Product Announcement

215250 PIPE BRACKET, HD ONE-PIECE POLY FOR 2.5" PIPE
 215350 PIPE BRACKET, HD ONE-PIECE POLY FOR 3.5" PIPE

Implementation Date: December 1st, 2012

215250 and 215350

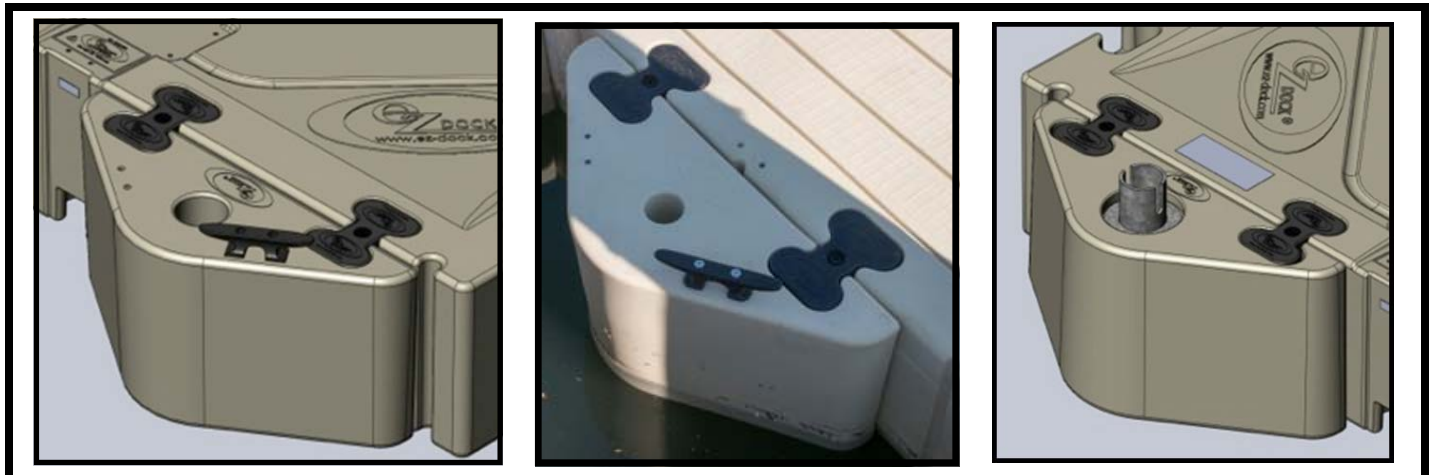
Introducing EZ Dock's new style Heavy Duty (HD) Pipe Brackets (215250 and 215350). This new bracket is similar to the existing HD pipe bracket but constructed of a single component LLDPE main frame. T-nut locations have been added to the top to allow for mounting of cleats directly on the bracket. This bracket can also be installed upside down; where a recess has been added for a deadweight insert.
